**BALL STATE UNIVERSITY  
SCHEIDLER APARTMENT COMPLEX  
BUILDING IMPROVEMENTS PHASE 10  
BSU Project No. 2011-029.01 SR  
MSKTD Project No. 5803  
Wednesday, May 4, 2011**

**ADDENDUM NO. D-1**

**BALL STATE UNIVERSITY  
SCHEIDLER APARTMENT COMPLEX  
BUILDING IMPROVEMENTS PHASE 10  
BSU Project No. 2011-029.01 SR  
MSKTD Project No. 5803**

SHEET NUMBER  
**A2.1**

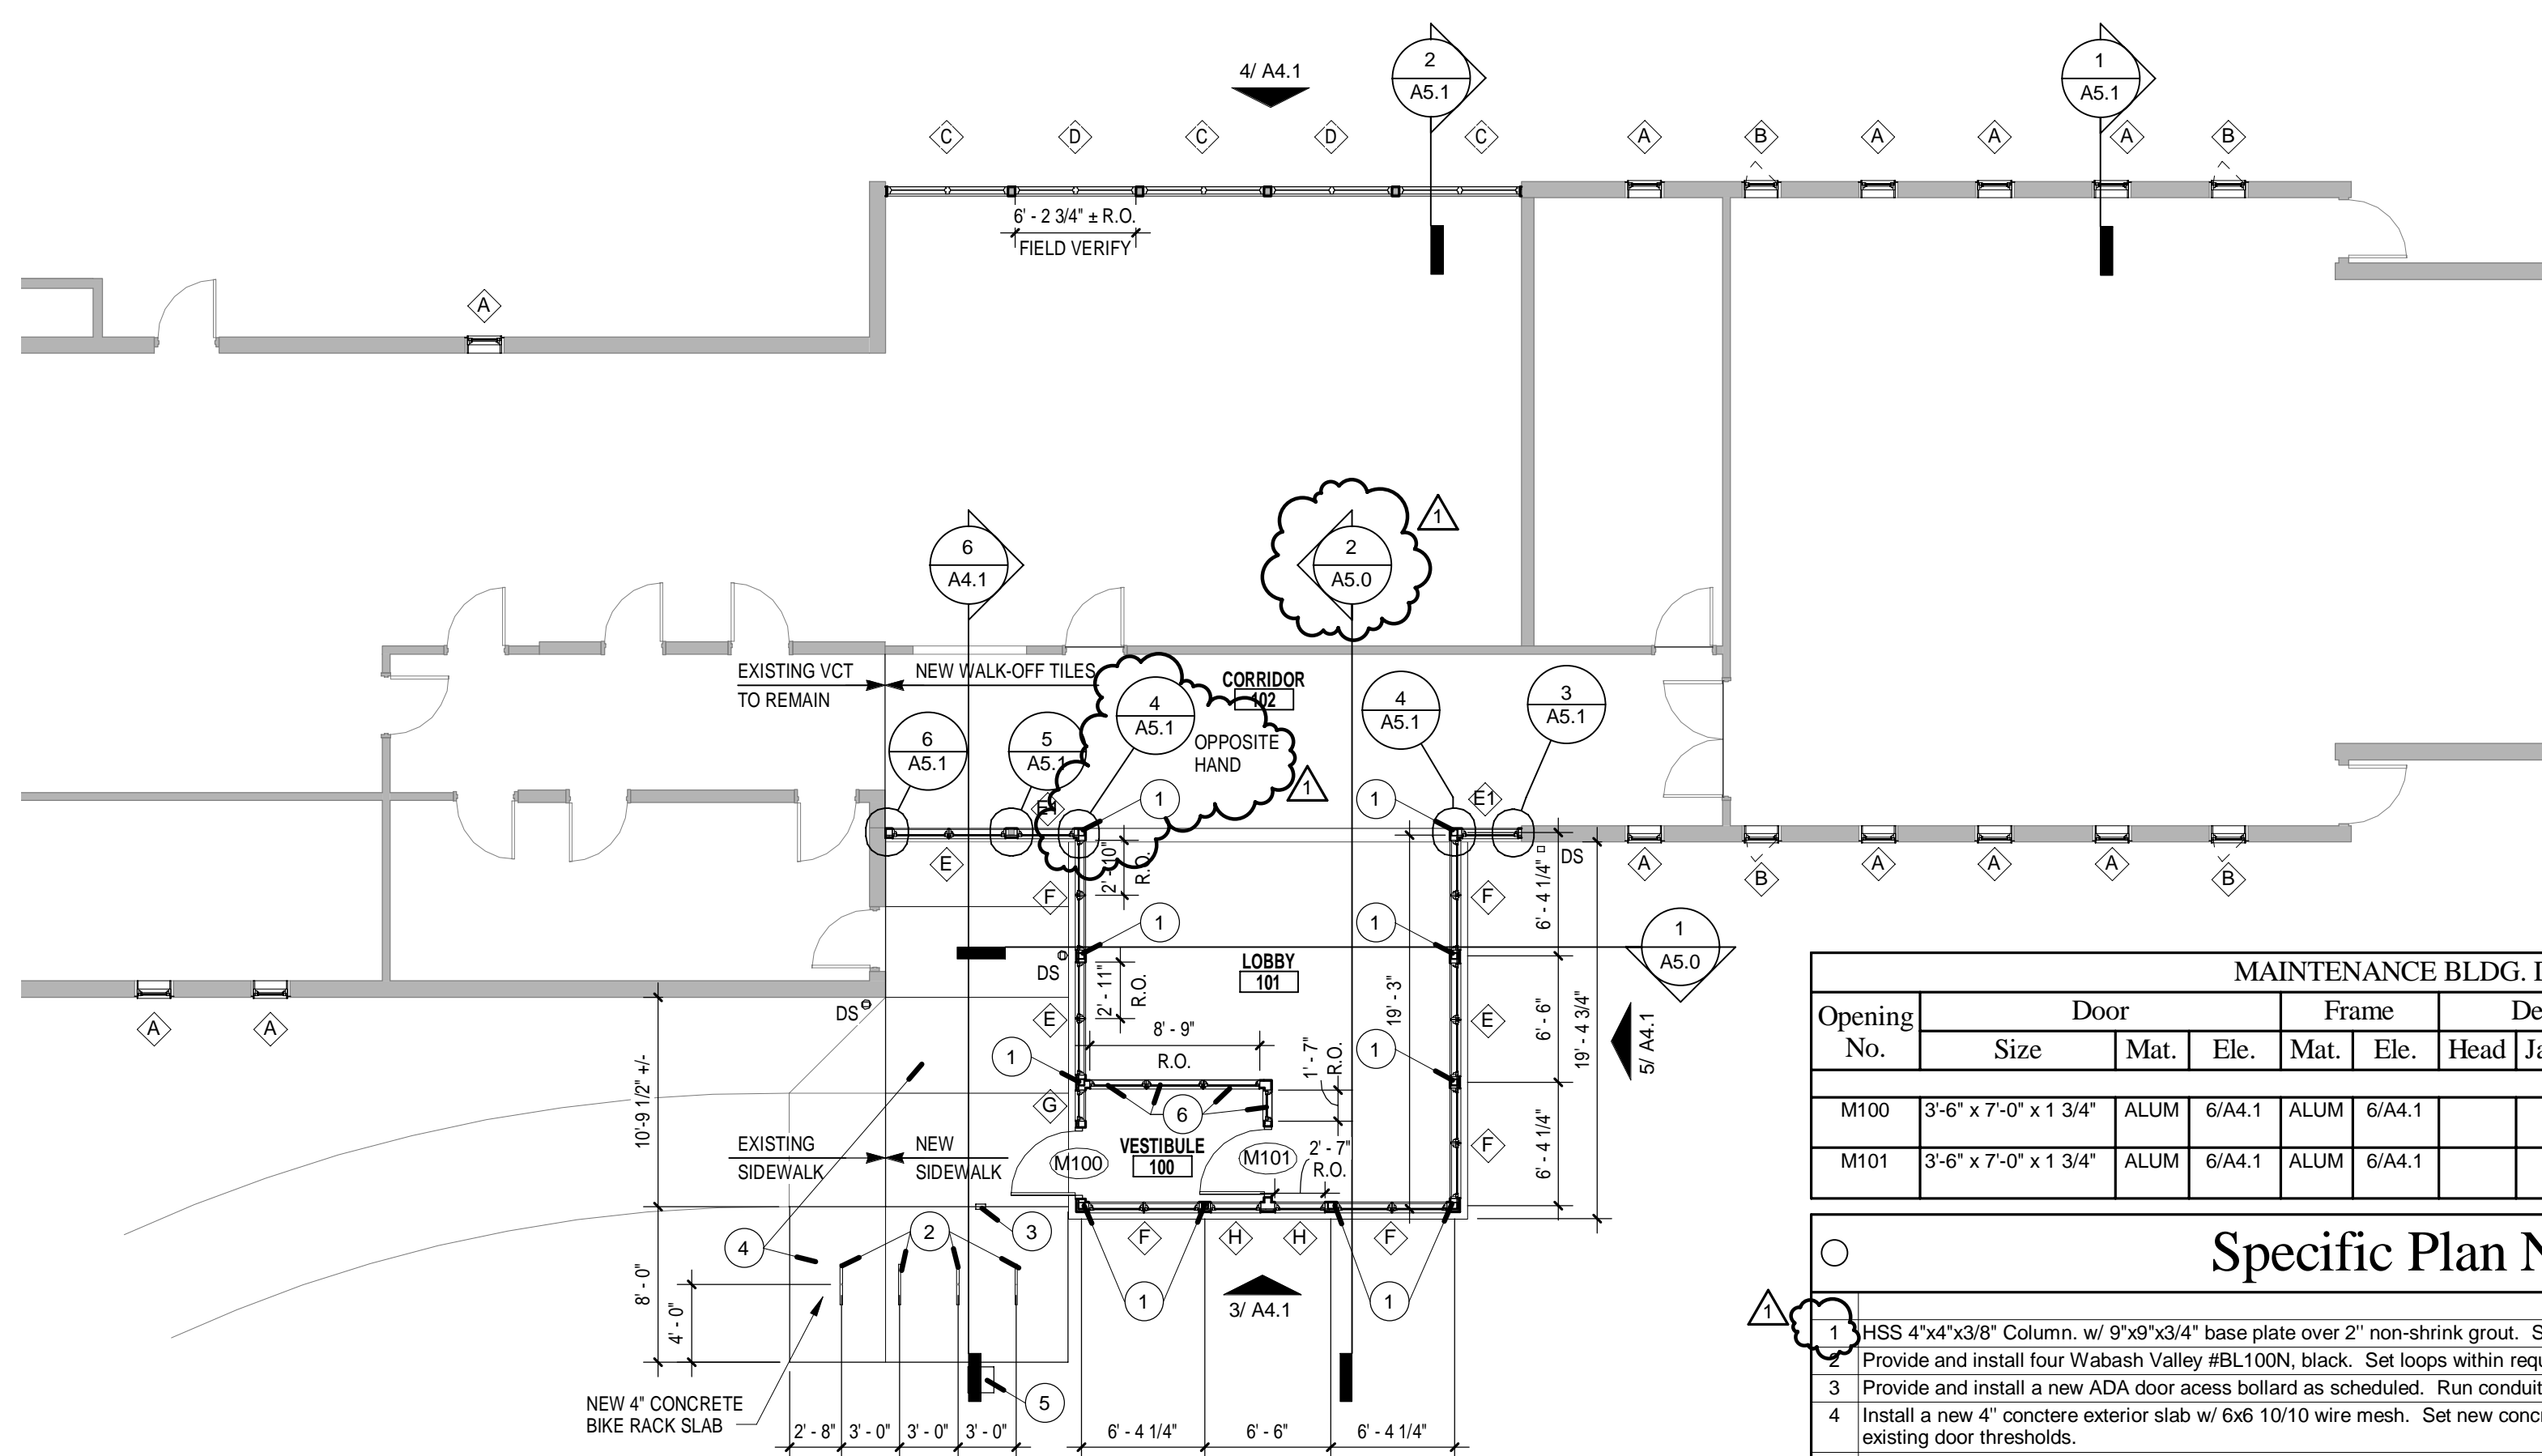
- D1.5 Drawings Sheet A2.1 Sheet A2.1 is reissued with the following revisions. See attached revised sheet A2.1.
1. At Specific Plan Notes- Maintenance, change Note #1's reference to "See A5.0" NOT A6.1.

2. At the Maintenance Building Floor Plan, add reference bubble 4/A5.1 to the east inside corner between Lobby #101 and Corridor #102.
  3. Note that Section 2/A5.0 has been revised.

SHEET NUMBER  
**A5.0**

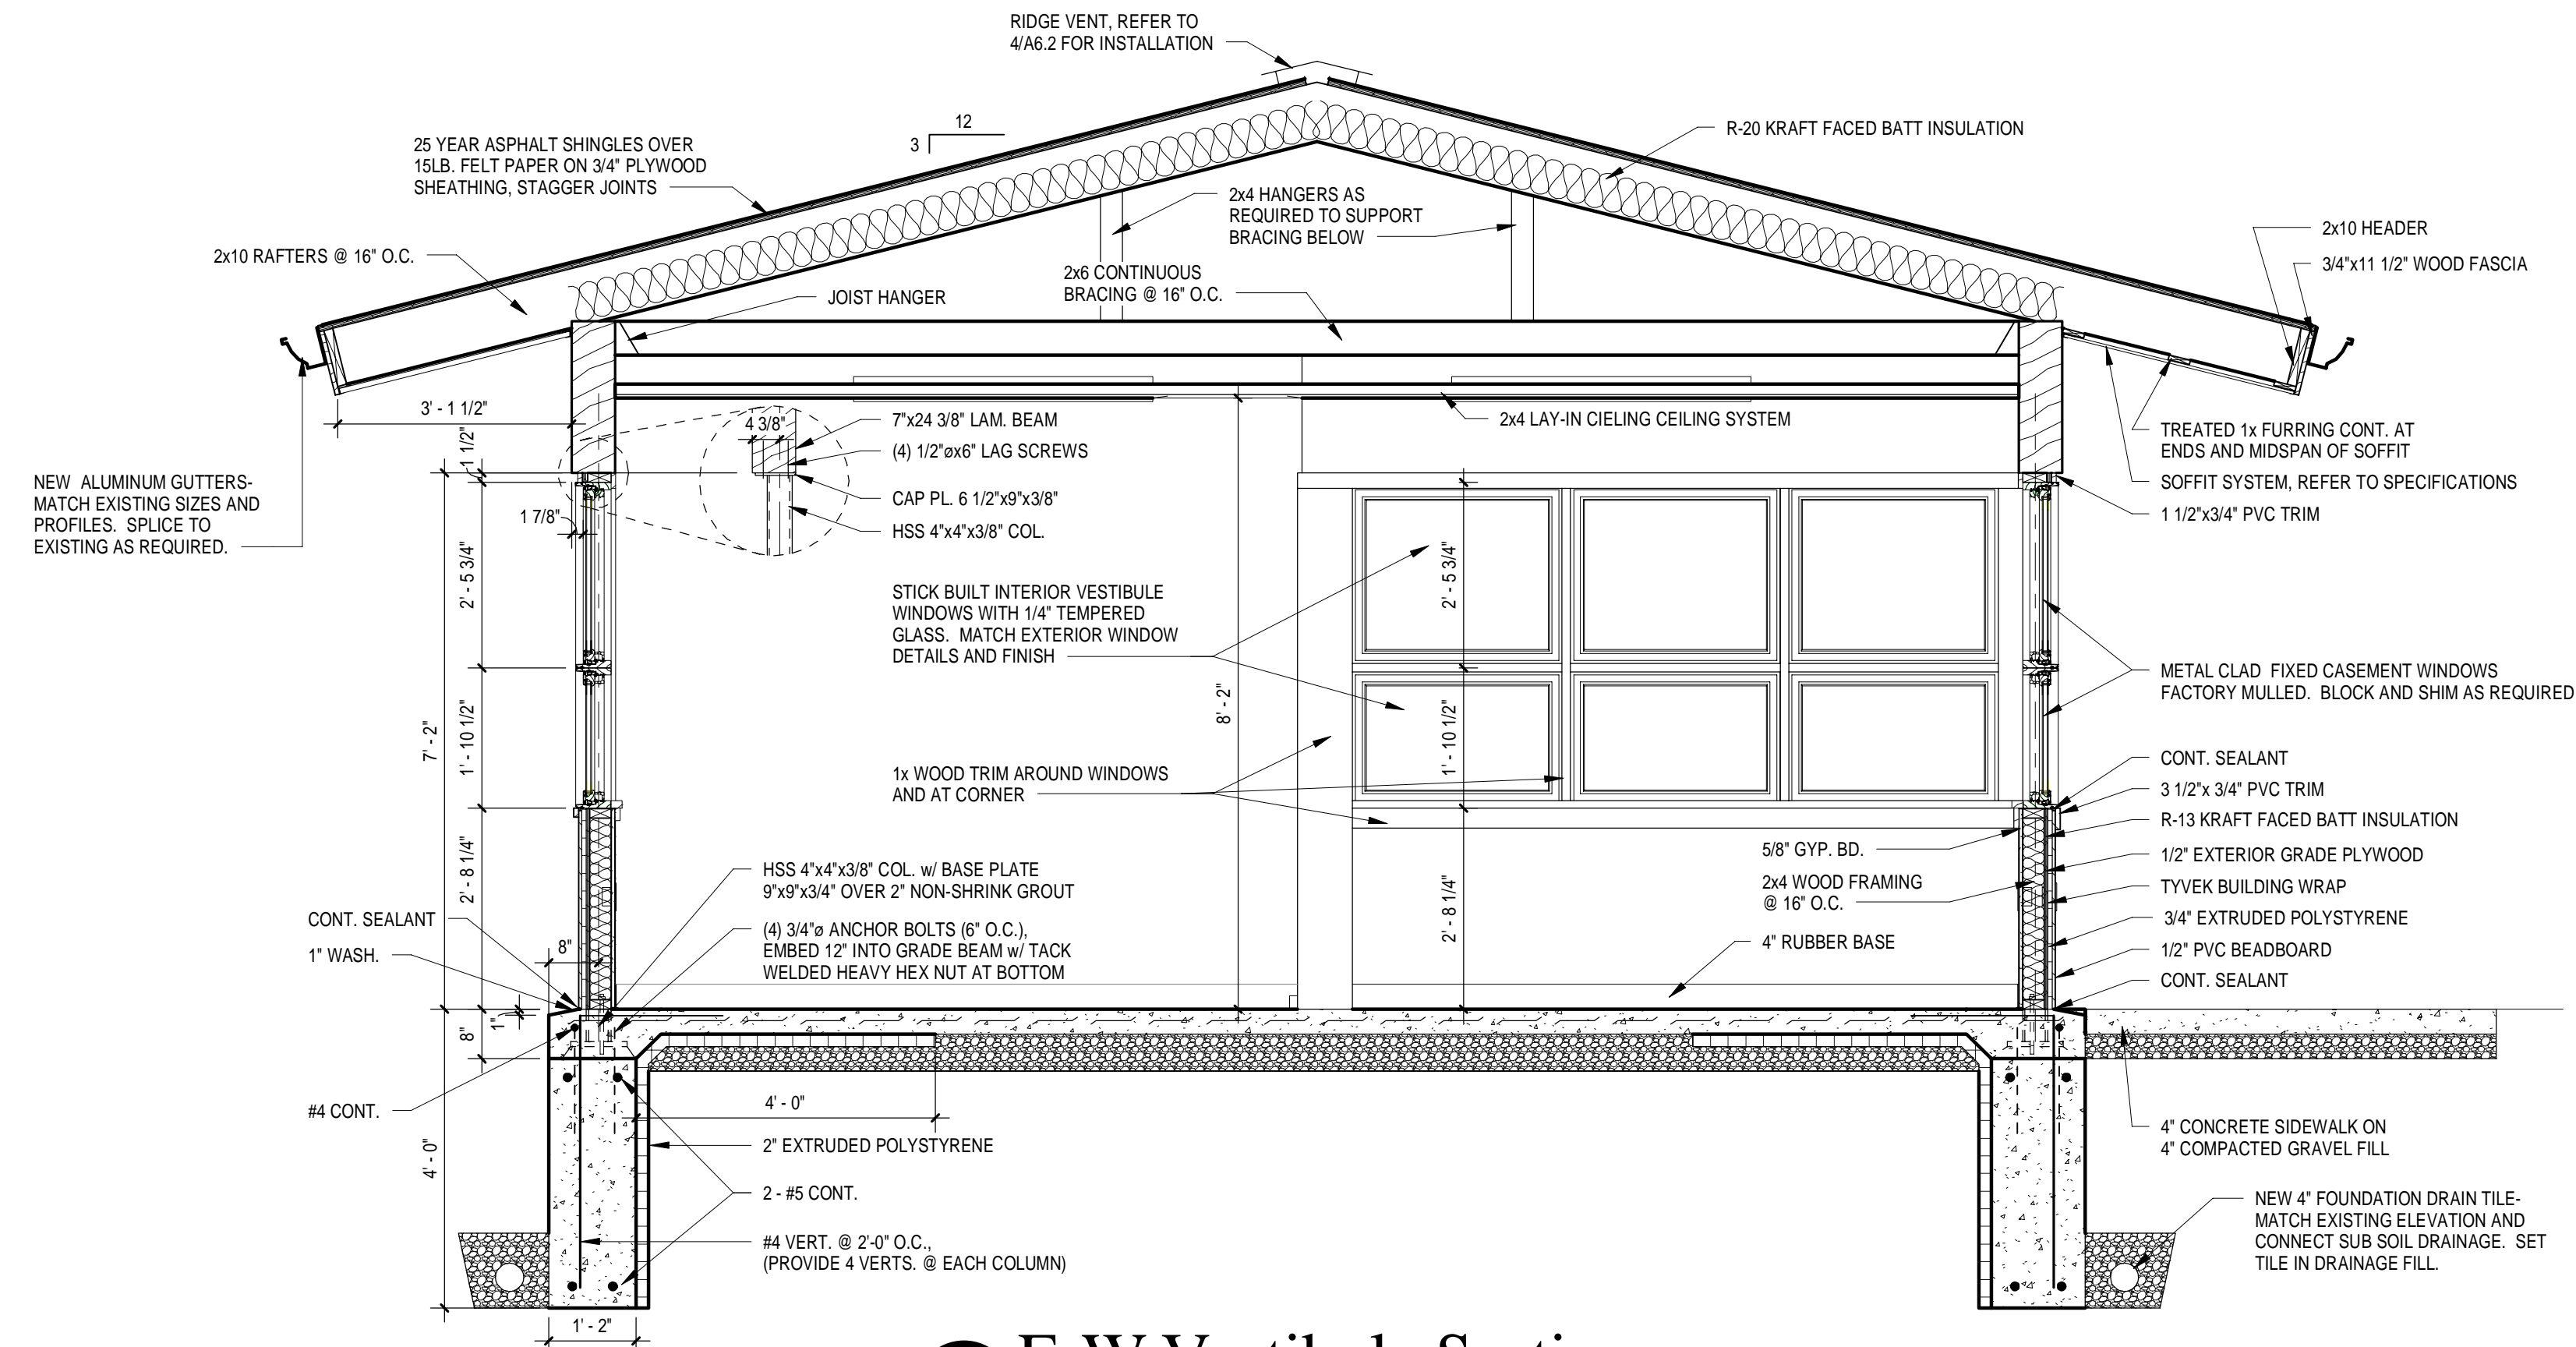
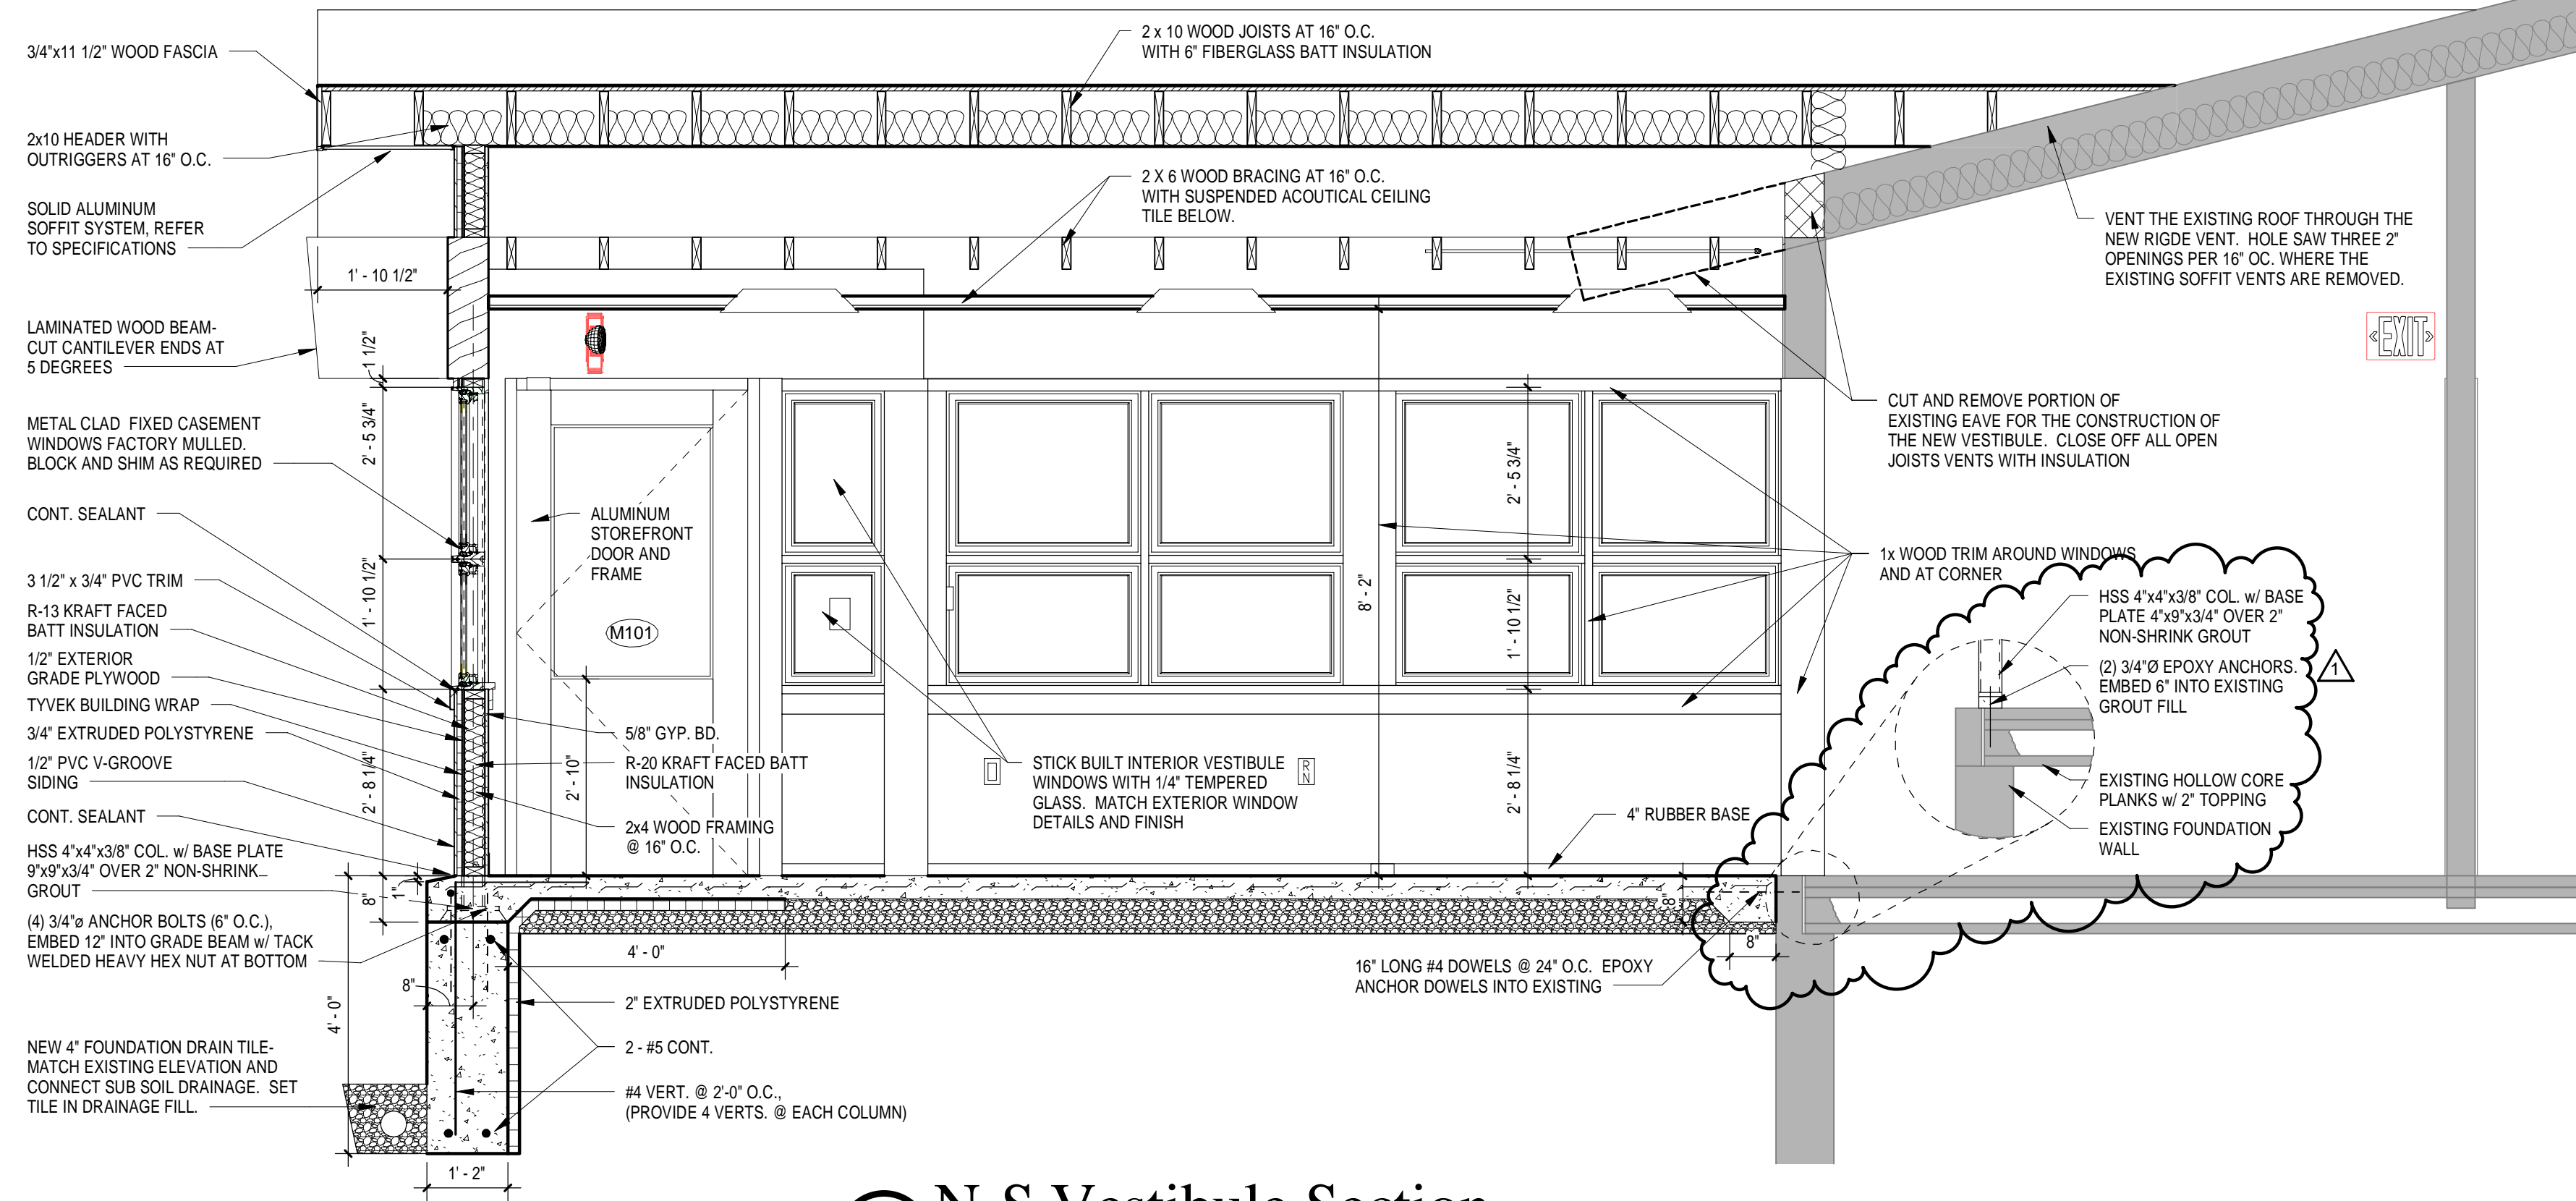
- D1.6 Drawings Sheet A4.3 At Specific Note #1 change the referenced sheet from A5.3 to A4.3.
- D1.7 Drawings Sheet A5.0 Sheet A5.0 is reissued with the following revisions. See attached revised sheet A5.0.

1. Add a new steel column detail to Detail #2. Note that this is a new steel column that supports the existing laminated roof beam.
- D1.8 Drawings Sheet A5.1 Details 4, 5, and 6. At all details delete the "adhered gypsum board" and clad the entire column/jamb with match 1x pine boards with clear finish.
